Proposed Change Orders for October 2025
BG #21-072 New Stanton Elementary School
Powell County Board of Education

Tier 1 Project: New Stanton Elementary School
BG Number: 21-072 District: Powell County (HB678) (495)
Status: Active Phase: Project Initiation (View Checklist)

THE CONTRACT IS CHANGED AS FOLLOWS: PR #11 - Revision to the design of the water main to be compliant with local utility company requirements.

THE CONTRACT IS CHANGED AS FOLLOWS: PR #18 - Revise the design of the relocated force main to be compliant with local utility company requests.

1 SITE UTILITY PLAN

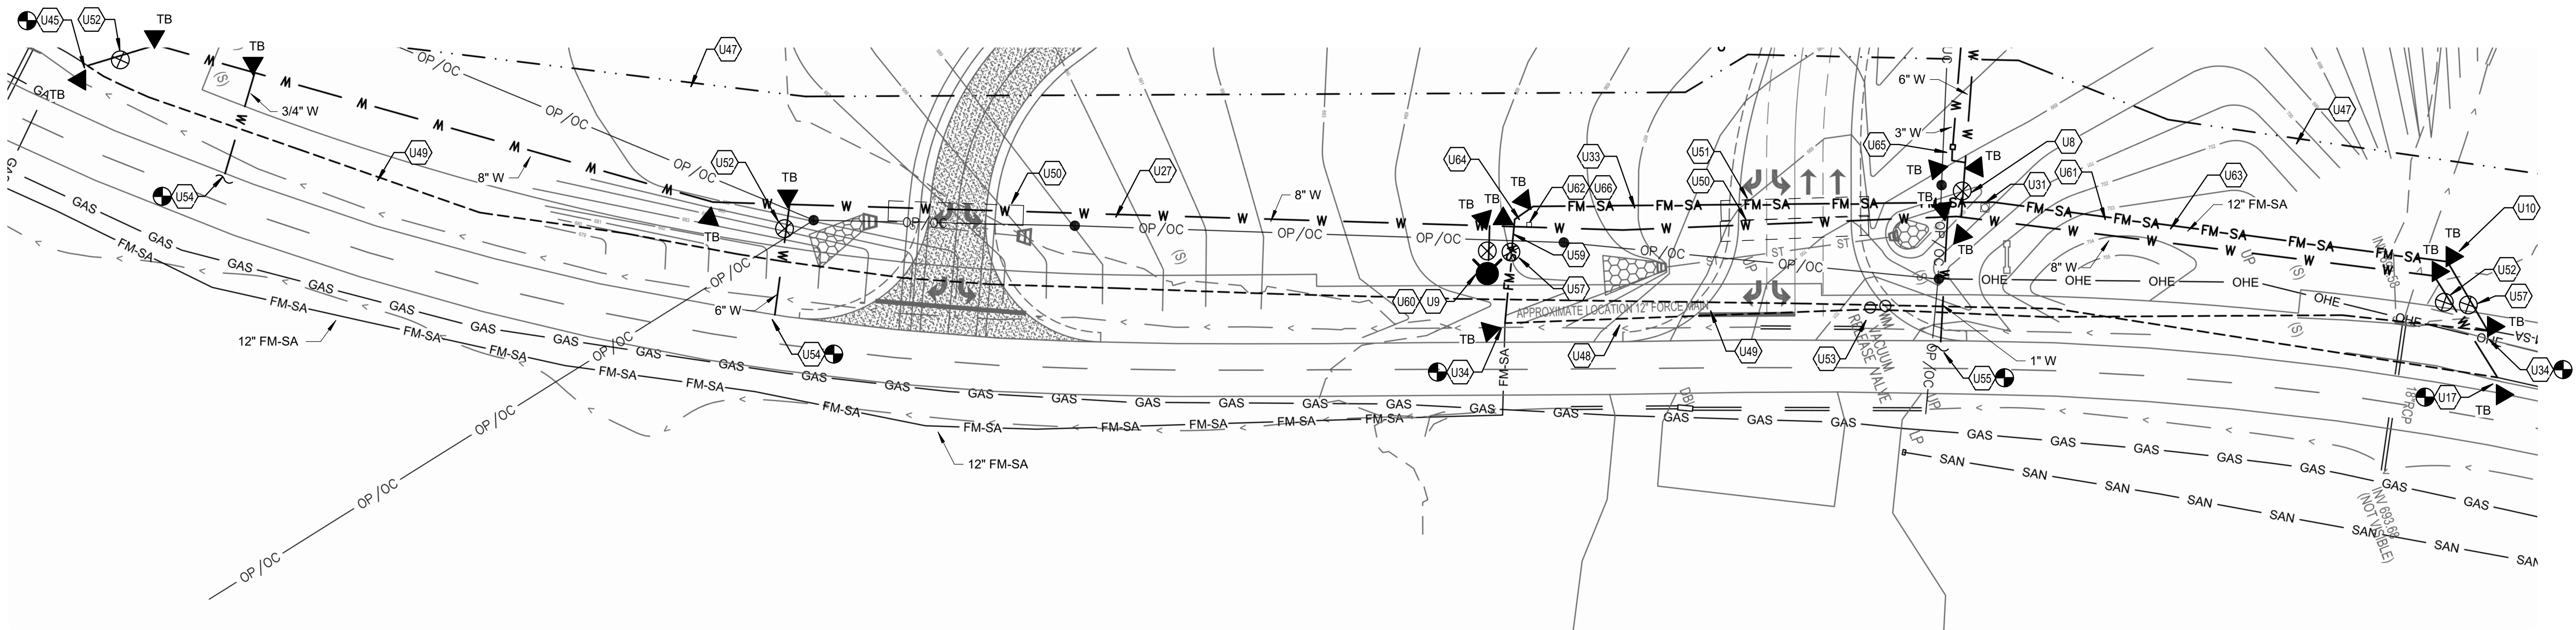
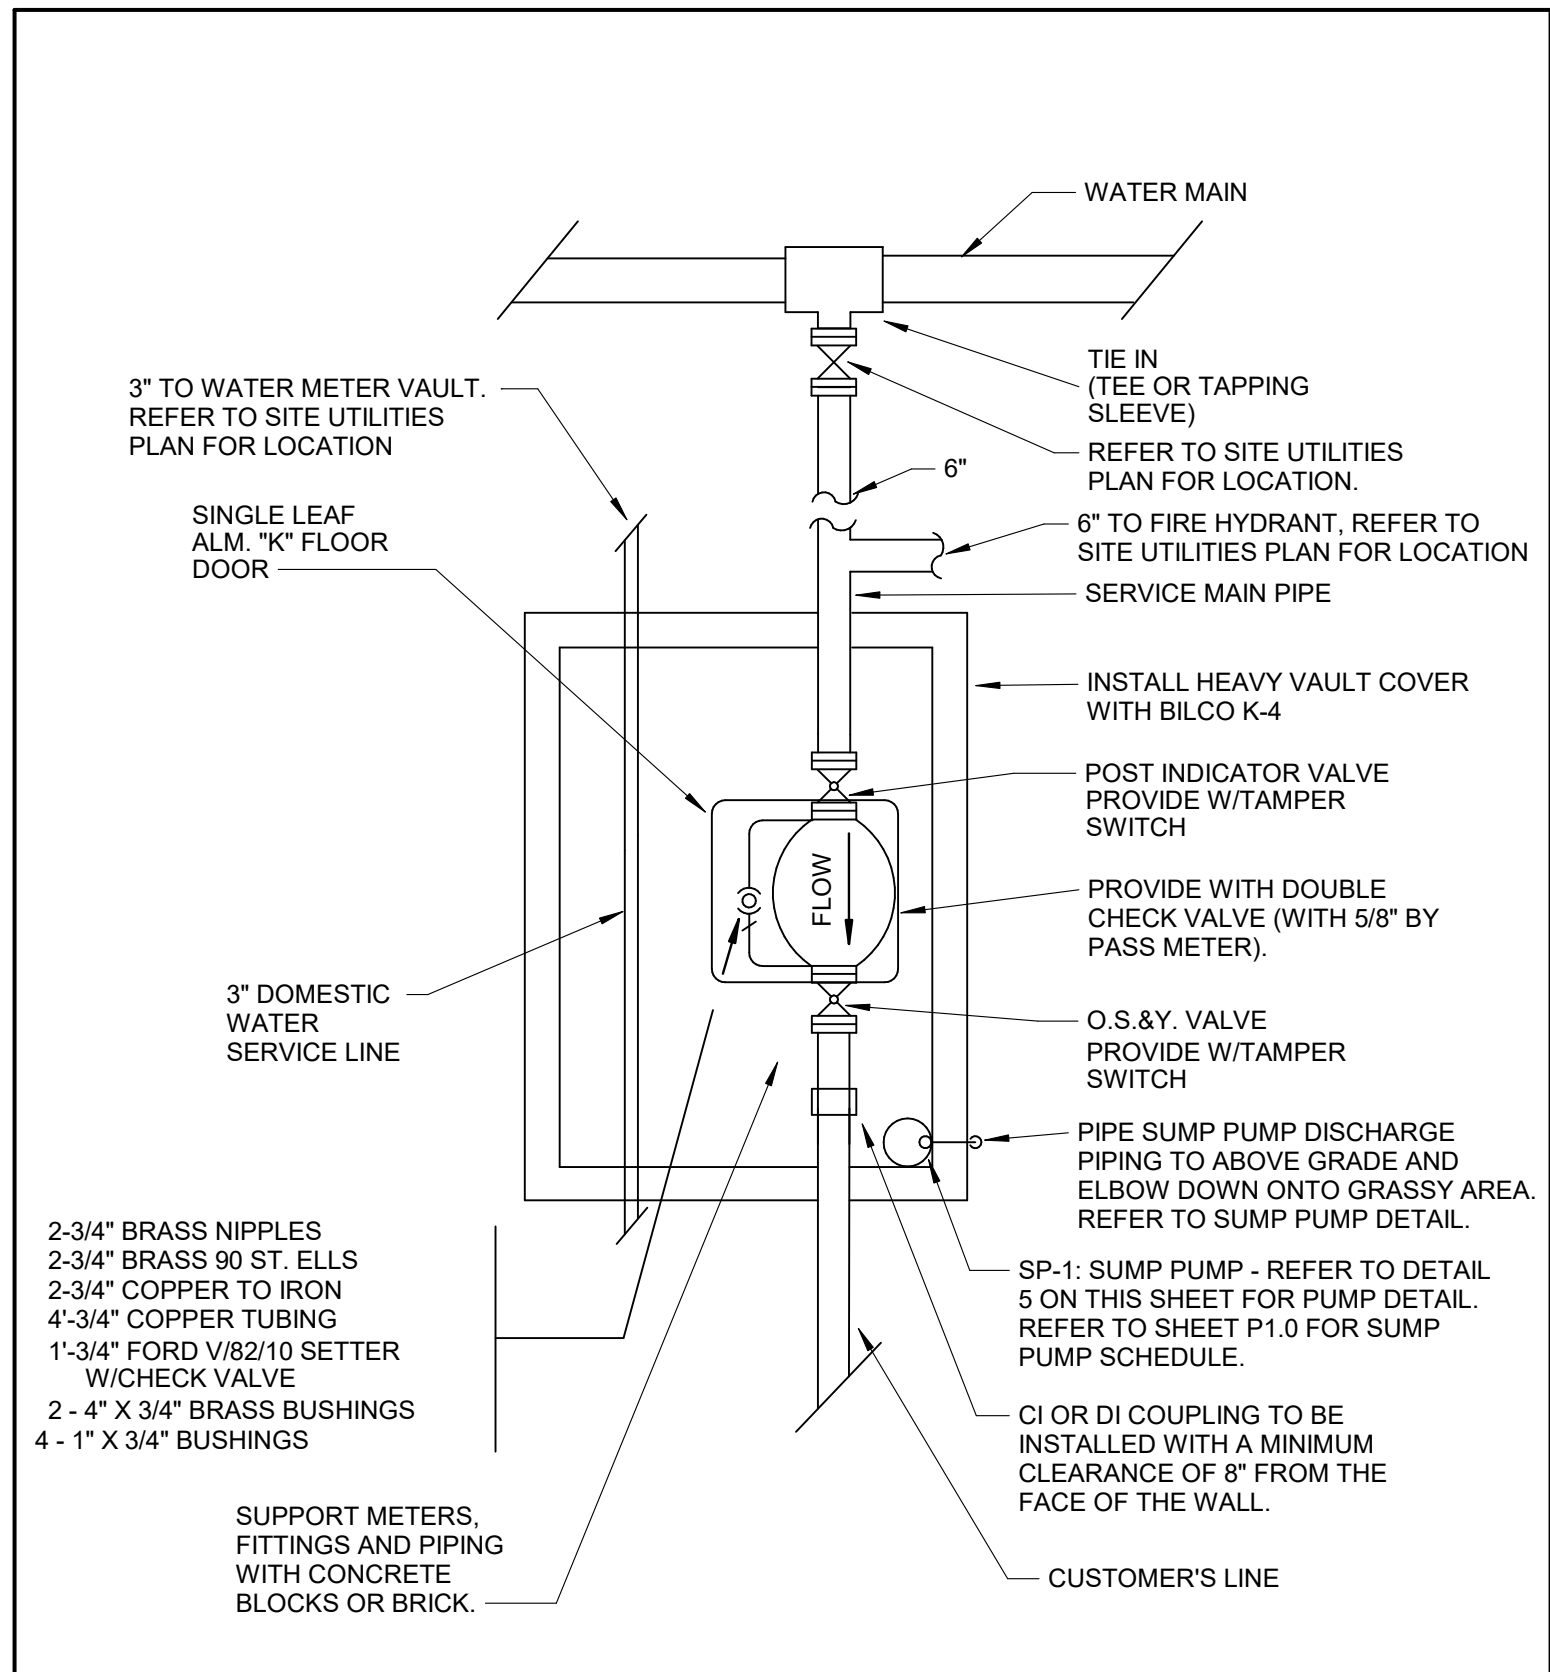
- U51 20" STEEL CASING SLEEVE FOR FORCE MAIN UNDERNEATH PAVEMENT.
- U52 WATER VALVE.
- U53 REMOVE VACUUM RELEASE VALVE.
- U54 REROUTE WATER FEED LINES TO UTILITIES ON OPPOSITE SIDE OF ROAD. FIELD VERIFY EXACT LOCATION.

- U55 REROUTE WATER FEED LINES TO UTILITIES FOR WELLS FUNERAL HOME ACROSS THE ROAD. FIELD VERIFY EXACT LOCATION.
- U57 PROVIDE GATE VALVE FOR FORCE MAIN.

- U61 MAINTAIN A MINIMUM OF 10 FEET OF SEPERATION BETWEEN FORCEMAIN AND WATER MAIN.
- U62 PROVIDE TRACER WIRE AND MARKING TAPE ABOVE NEW FORCE MAIN AS INDICATED IN THE SPECIFICATIONS. PROVIDE PVC BOX ENCASED IN A 18" BY 18" CONCRETE PAD FLUSH WITH GRADE. ROUTE TRACER WIRE TO BOX FOR ACCESSIBILITY.

- U63 FORCEMAIN SHALL BE 12" PVC SDR-21 PIPE.
- U64 90° BEND FITTINGS ARE NOT ALLOWED ON FORCEMAIN PIPING.
- U65 PROVIDE WATER METER VAULT AS REQUIRED BY THE LOCAL WATER COMPANY. WATER METER VAULT SHALL BE ENCASED IN A 24" BY 24" CONCRETE BOX AND BE INSTALLED FLUSH WITH GRADE AND INSIDE THE NEW PROPOSED RIGHT OF WAY.
